SYDNEY WESTERN CITY PLANNING PANEL

Panel Reference	2017SSW021
DA Number	DA-993/2016
LGA	Liverpool City Council
Proposed Development	Demolition of existing buildings and the construction of a five storey residential flat building containing thirty residential units with basement car parking and ancillary site works. The development is lodged pursuant to the State Environmental Planning Policy (Affordable Rental Housing) 2009.
Street Address	129 & 131 Memorial Avenue, Liverpool
Applicant	Ms I Kathia
Land Owners	Ms I Kathia
Date of DA lodgement	24 October 2016
Number of Submissions	Nil
Recommendation	Approval, subject to conditions of consent
Regional Development Criteria (Schedule 4A of the EP&A Act)	The proposal is for an affordable housing development that has a capital investment value of over \$5 million, the Joint Regional Planning Panel is therefore the determining authority.
List of all relevant s79C(1)(a) matters	<p>1) <i>List all of the relevant environmental planning instruments: s79C(1)(a)(i)</i></p> <ul style="list-style-type: none"> • State Environmental Planning Policy (Affordable Rental Housing) 2009 • State Environmental Planning Policy No.65 – Design Quality of Resi

Figure 4 – Potential ground floor level building envelope for the neighbouring site to the east

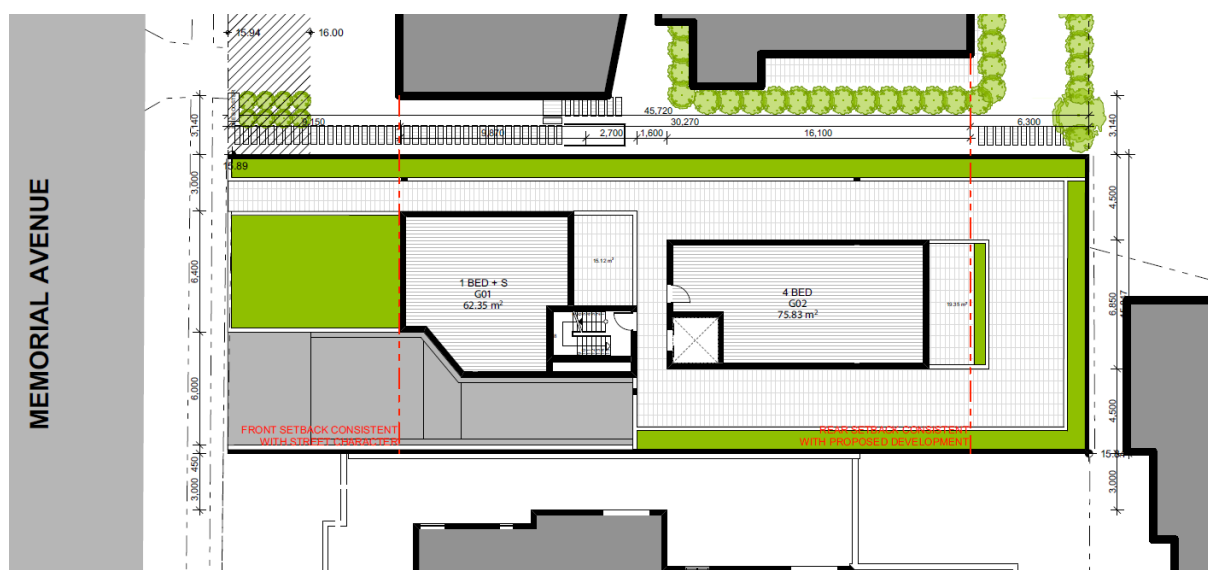
The applicant has prepared a concept plan for the neighbouring lot at 127 Memorial Avenue that indicates height, setbacks, site coverage (both building and basement). An extract from the architectural plans submitted for the adjoining site has been reproduced below in Figure 4. This can be found in Attachment 14.

Nevertheless, having regard to the submitted concept, it is prudent to provide an indicative floor layout so as to demonstrate how the development will balance requirements for cross flow ventilation, solar access and privacy. The applicant is reluctant to provide such information as the submitted plans can be refined at the detailed design stage to balance all requirements. Council is satisfied that the submitted scheme has scope to achieve a development of appropriate urban form and with an acceptable level of amenity.

The concept plan shows that a residential flat building is developable on this site in the future and no objection is raised to the overall scheme presented to Council.

Figure 7 – Extract of the floor plan that shows the extent of non-compliance with Building Depth on Level 1

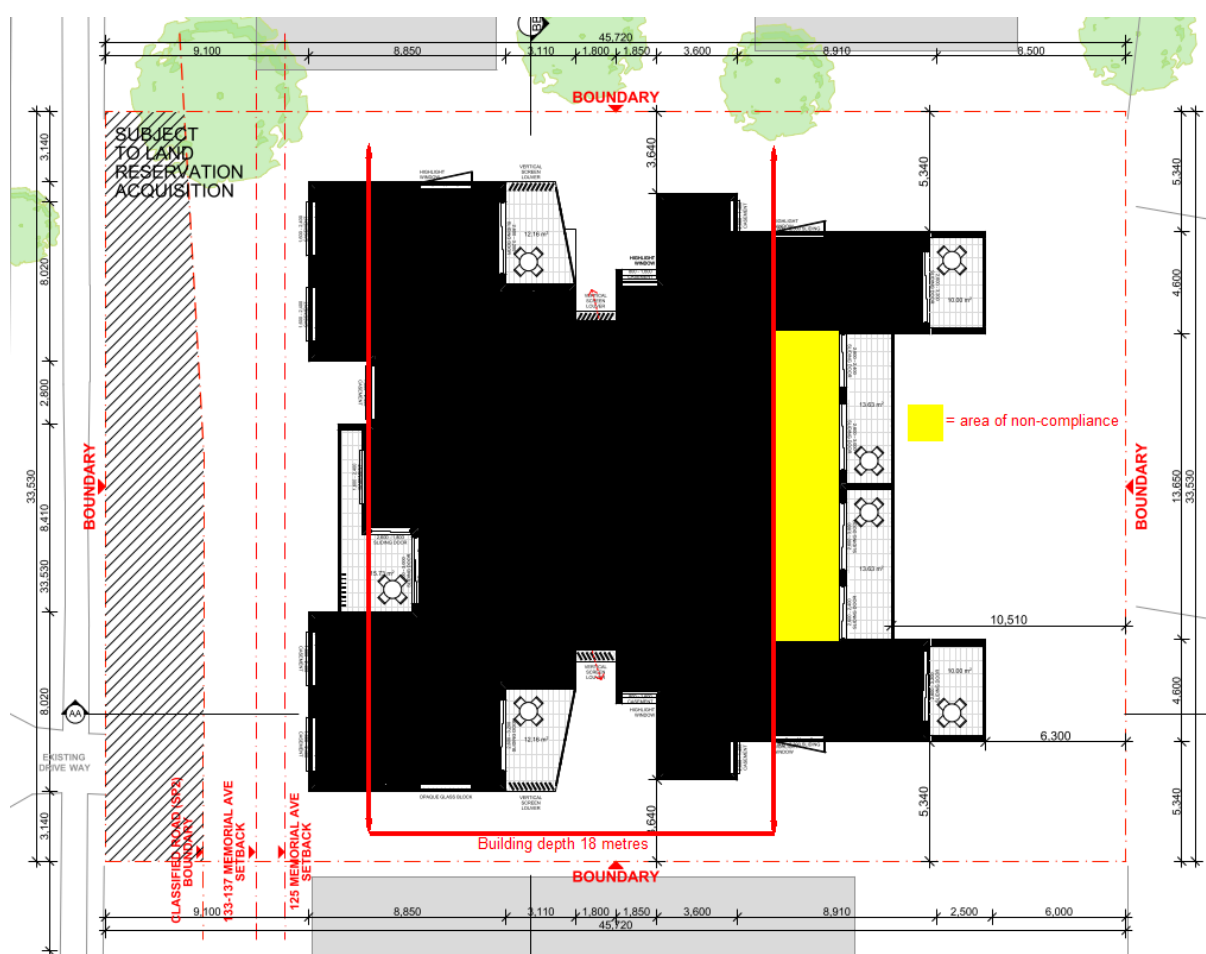
The ADG recommends maximum apartment depths of 12-18m from glass line to glass line. The proposed development generally provides a building depth of 28m. These areas of non-compliance on Level 1 can be seen in **Figure 7** below.

Due to future road widening, the site is constrained in that the land available for development is reduced by 140m² (9%). In conjunction with the additional floor space permitted by virtue of the ARH SEPP, a variation to the building depth is considered acceptable to accommodate the proposed development. Although the buildings exceed the recommended building depths provided by the ADG, the internal layout of the apartments have been designed to ensure that sufficient solar access and natural ventilation is provided. 70% of the apartments will receive a minimum of 3 hours of solar access and 66% of the apartments are cross ventilated. Council's DEP have reviewed the application and considered the application worthy of support.

Figure 8 – Extract of the floor plan that shows the extent of non-compliance with Building Separation on Level 1

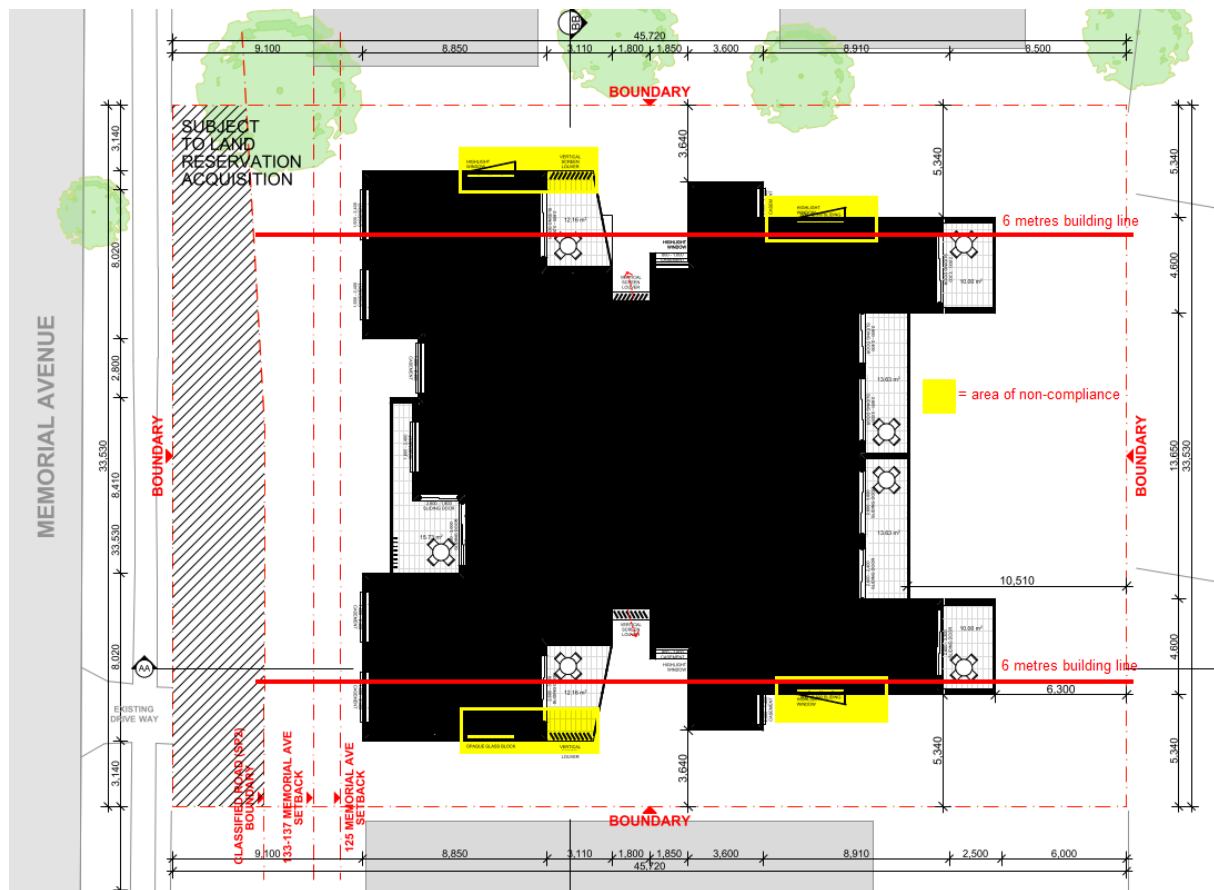
The proposed RFB contains windows to habitable rooms on the eastern and western elevation on all three levels. In this regard, a 6m building separation distance from the side property boundary is applicable (i.e. between habitable rooms/balconies) to all three levels. The application proposes a separation distance of 3.1m for dwellings orientated to the street and 5.3m to dwellings positioned at the rear of the building. These areas of non-compliance can be seen in **Figure 8** below.

Figure 10 – Extract of the floor plan that shows the extent of non-compliance with Building Separation on Level 4

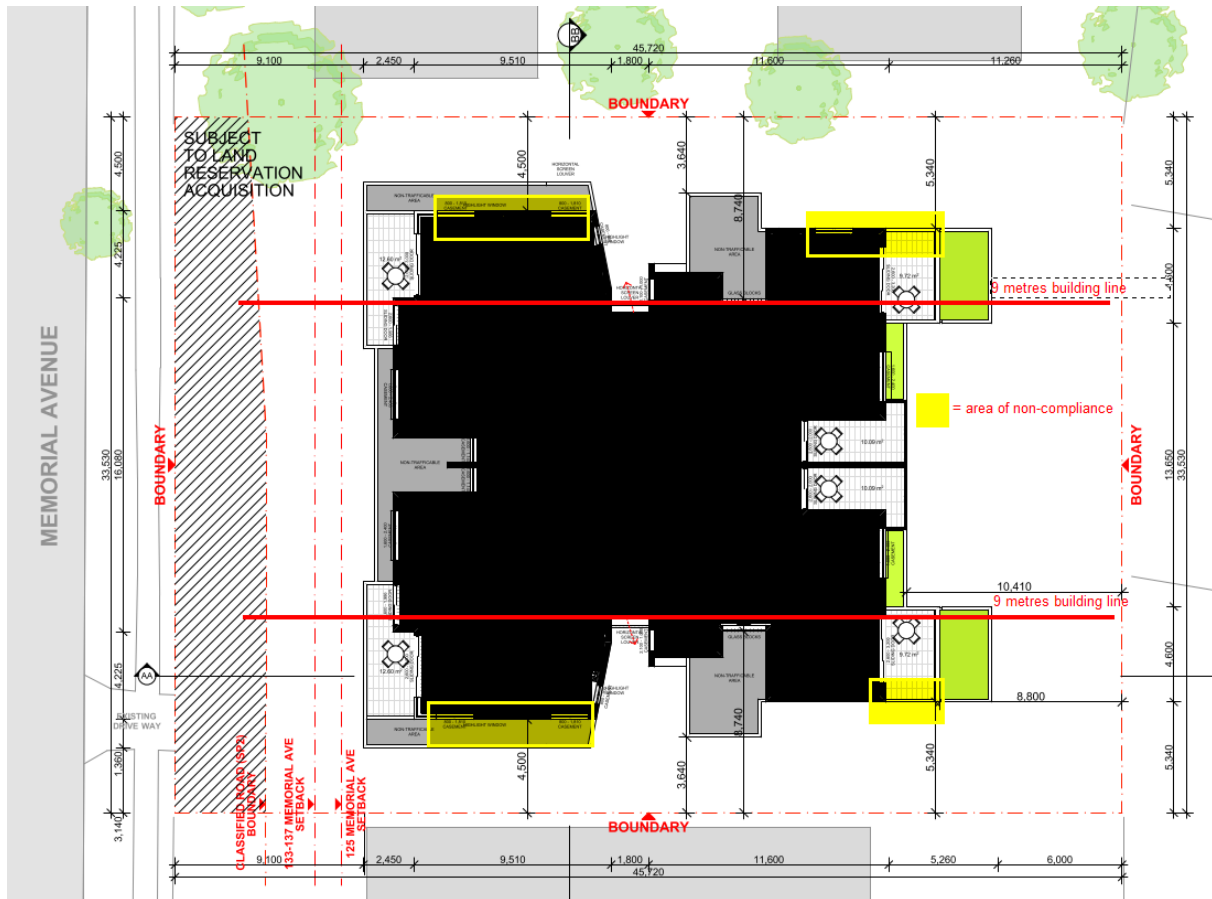
Also, the building separation distances of Levels 4 of the proposed RFB do not achieve compliance with the requirements of the ADG, which stipulates:

The proposed RFB contains windows to habitable rooms on the eastern and western elevation on Level 4. In this regard, a 9m building separation distance from the side property boundary is applicable (i.e. between habitable rooms/balconies). The application proposes a separation distance of 4.5m for dwellings orientated to the street and 5.3m to dwellings positioned at the rear of the building. These areas of non-compliance can be seen in **Figure 10** below.

The subject site is affected by a classified road acquisition on Memorial Avenue that comprises approximately 9% of the site area. The site is constrained as the land available for development is reduced due to this future road widening. In conjunction with the additional floor space permitted by virtue of the ARH SEPP, variations to the building separation are considered acceptable to accommodate the proposed development.

Figure 11 – Extract of the section plan showing the building elements which exceed the height limit.

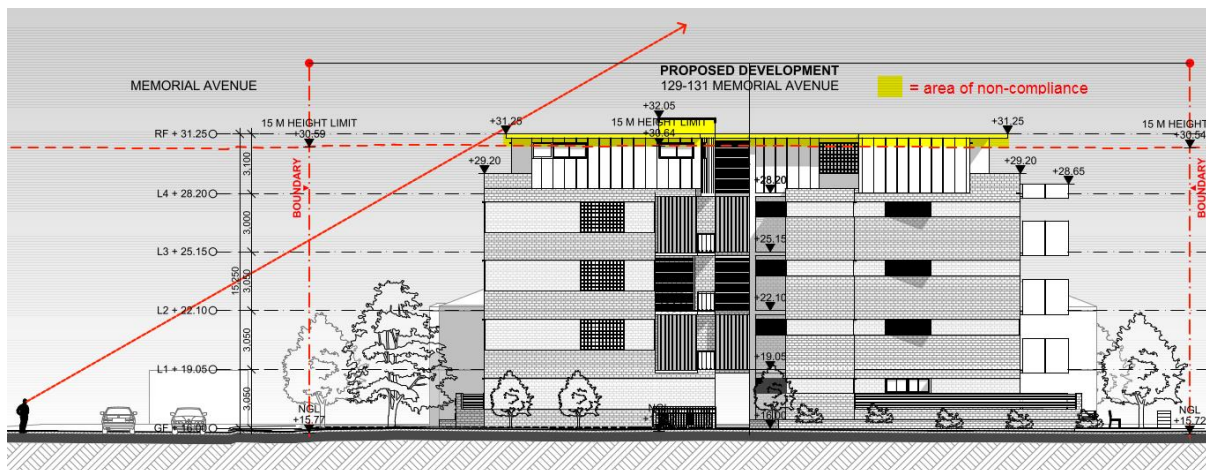
Clause 4.3(2) of the LLEP 2008 identifies a maximum height of 15m for the site.

The development proposes a maximum height of 15.42m to roof slab which represents a numerical variation of 420mm or 2.8% and a maximum height of 16.17m to lift overrun which represents a numerical variation of 1.17m or 7.8%. As demonstrated below, the non-compliant height relates to a portion of level 4 of the development and lift overruns.

In response to the applicant's submission, Council accepts that strict compliance with the applicable height control is unreasonable and unnecessary having regard to the following:
